RE: **FedEx Fuel Station**
Daytona Rd NW
Grading Plan Stamp Date: 5/29/18
Hydrology File: K09D026C

Based on the information provided in your submittal received on 5/31/18, the grading plan cannot be approved for Site Plan for Building Permit or Building Permit until the following are corrected:

| | | SHEET # GR-1 |

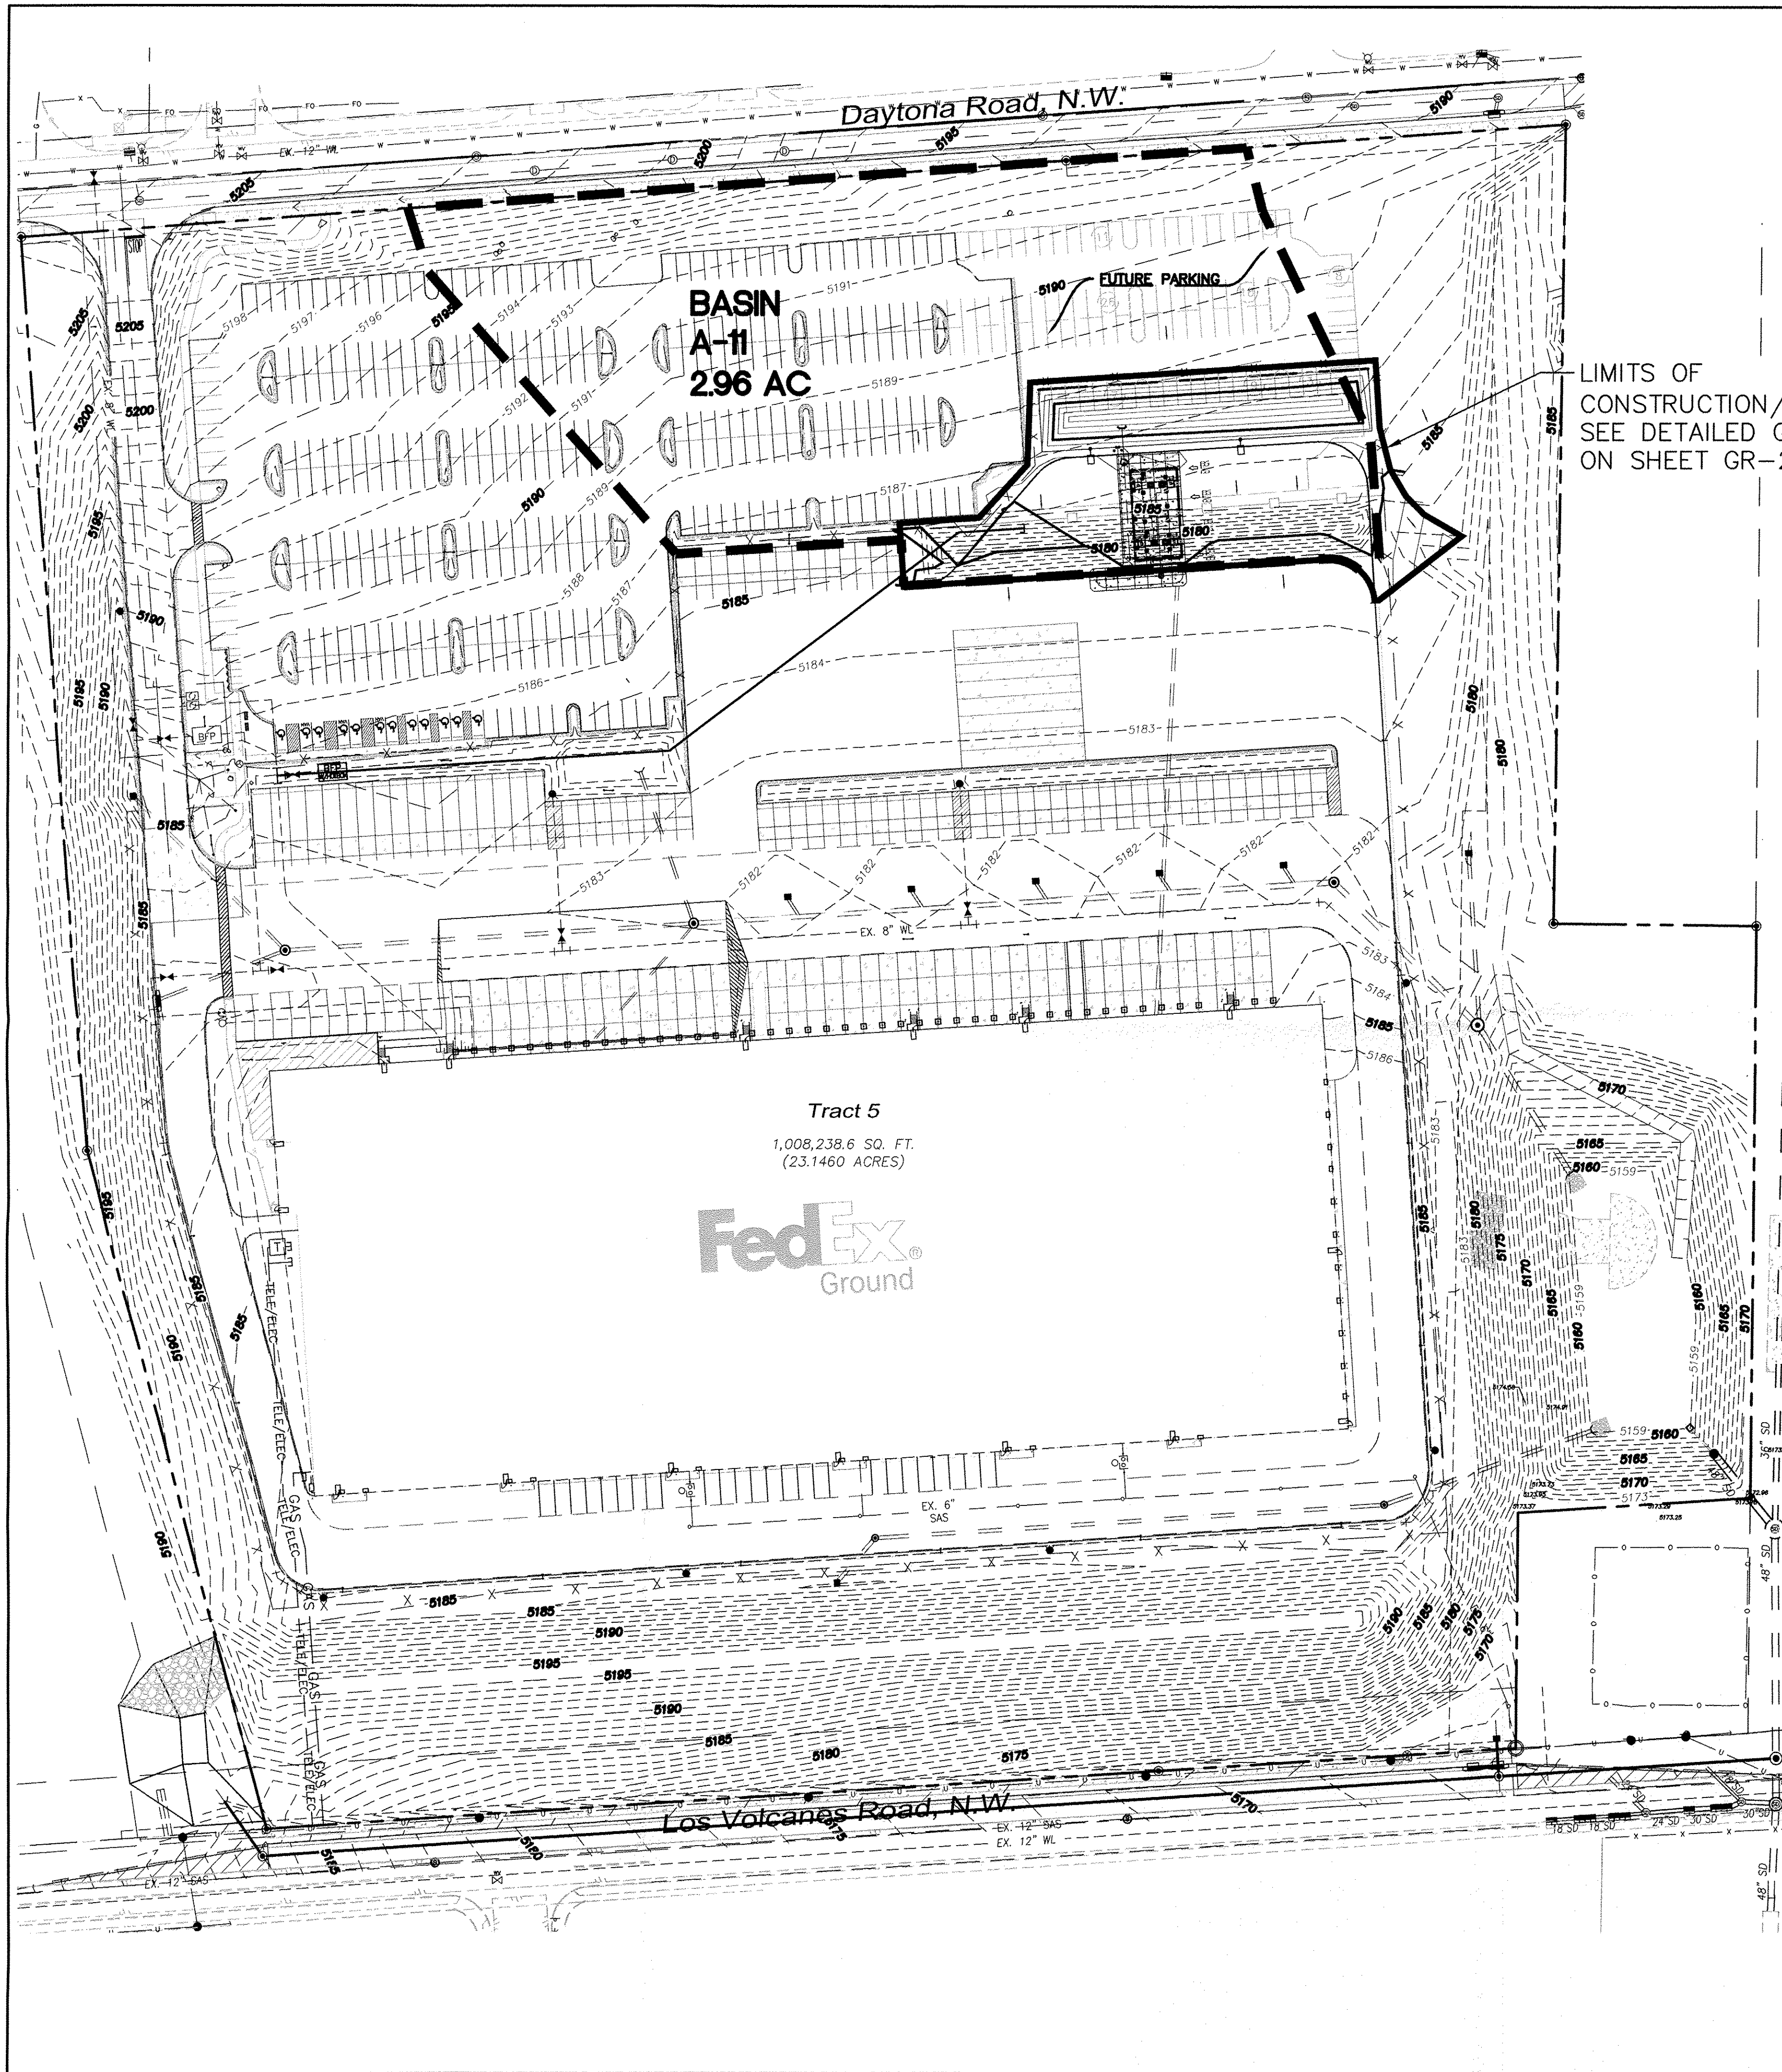
1. Include discussion of how the first flush is being retained on-site. Provide supporting calculations, drainage basin exhibits, etc demonstrating that the area of new impervious (and redeveloped impervious, if any) will be routed to an adequately sized first flush facility.

2. The proposed contours do not tie-in to existing along the edges of the project limits and appear to be drawn incorrectly. Increase the density of existing and proposed contour labeling and include minor labels.

3. The spot elevations do not agree with the contours; it is unclear if they are existing or proposed. Please differentiate the labels to specify and confirm they agree with the contour data.

5. The excavation and repaving for the UST should be included in the limits of work/grading.
6. For Information. Based on the information provided in this plan, Hydrology does not anticipate that public drainage infrastructure will be required. However an approved

| <p>RONALD R. BOHANNAN P.E. #7868</p> | <div data-bbox="2539 1821 2823 1874">  <p>TERRA WEST, LLC</p> </div> <p>5571 MIDWAY PARK PLACE NE ALBUQUERQUE, NM 87109 (505) 858-3100 www.tierrowestllc.com</p> | <p>2018025--BASE--GR</p> <p>SHEET # GR-2</p> <p>JOB # 2018025</p> |

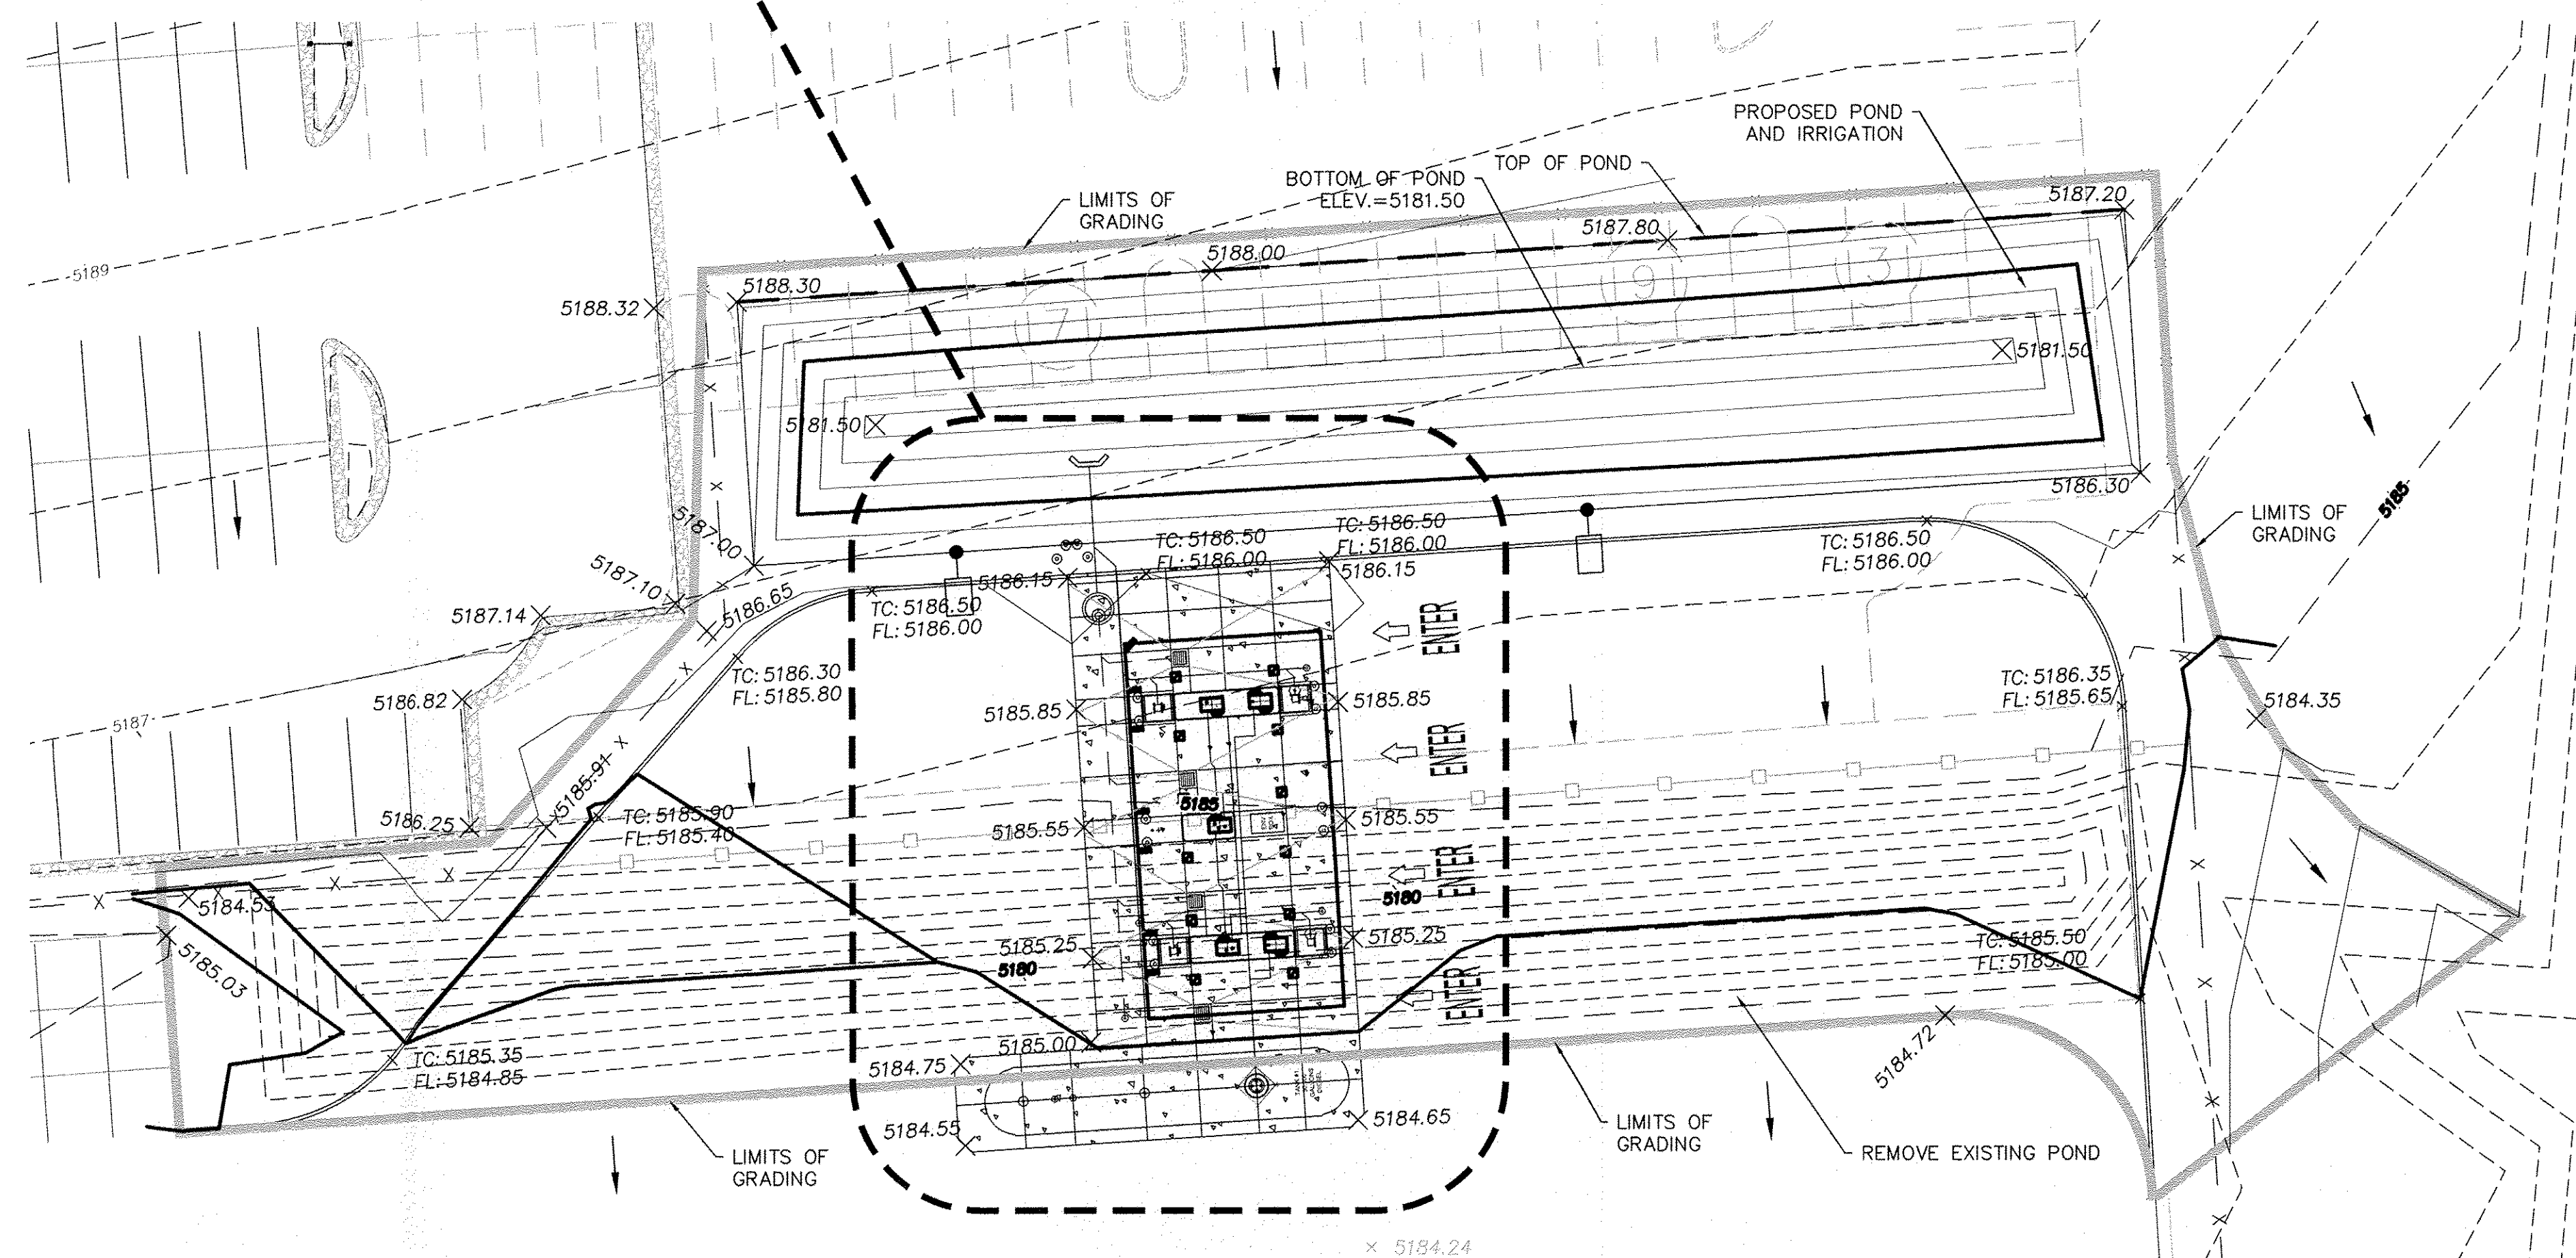
4. For fueling stations, demonstrate *control of oil from vehicle parking areas* per DPM Chapter 22.9.E, Table 1. The storm interceptor noted on sheet GR-2 appears to be intended for this, but it needs show that the parking area (around the fuel islands) is contained and drains to it. Please provide a specification for the storm interceptor and area inlets (notes B and C) as well.
